Access Compliance Report

Public Rights-of-Way

Intersection ID: 51582	Main Street: QUIVERING_OAK_LN	Cross Street: WESLEY_VILLAGE_RD	Location: NW
ADA ID: 02757B70087A	Ramp Type: Perp	Initial Pass/Fail: Fail	Overall Compliance: No
Severity Score: 8.75			
Codes/Mitigation Info/Possible Solution		Field Measurements/Component Compliance

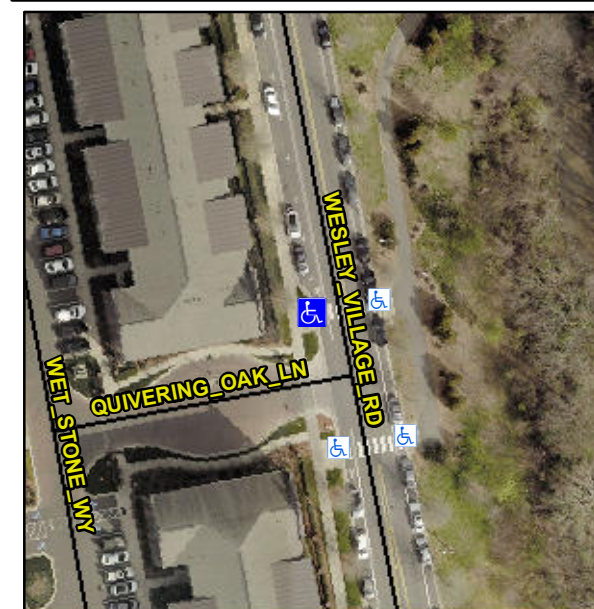
Not Found, R304.5.1

Compliance	Description	Data	Compliance	Description	Data
N/A	Ramp Length (in)	77.0	Yes	Ramp Slope (%)	5.0
No	Ramp Width (in)	47.0	Yes	Ramp XSlope (%)	0.7
N/A	Flare Type LT	N/A	N/A	Flare Type RT	N/A
N/A	Flare Slope LT (%)	N/A	N/A	Flare Slope RT (%)	N/A
N/A	Flare Traversable LT?	N/A	N/A	Flare Traversable RT?	N/A
N/A	Landing Length (in)	N/A	N/A	DWS Provided?	N/A
N/A	Landing Width (in)	N/A	N/A	DWS Contrast?	N/A
N/A	Landing Slope (%)	N/A	N/A	DWS Length (in)	N/A
N/A	Landing X Slope (%)	N/A	N/A	DWS Full Width?	N/A
N/A	Landing Curb? (Y/N)	N/A	N/A	DWS Offset (in)	N/A
N/A	Shared Landing?	N/A			
N/A	Gutter Ponding?	N/A	N/A	Gutter Slope (%)	N/A
N/A	Gutter Lip Ht (in)	N/A	N/A	Gutter X Slope (%)	N/A
N/A	Painted X Walk1?	Yes	N/A	Painted X Walk2?	N/A
	X Walk 1 Direction	To E		X Walk 2 Direction	N/A
N/A	X Walk 1 Width (in)	97.0	N/A	X Walk 2 Width (in)	N/A
	X Walk 1 Slope (%)	3.2		X Walk 2 Slope (%)	N/A
	X Walk 1 X Slope (%)	1.3		X Walk 2 X Slope (%)	N/A

Remove & Replace Entire Ramp.
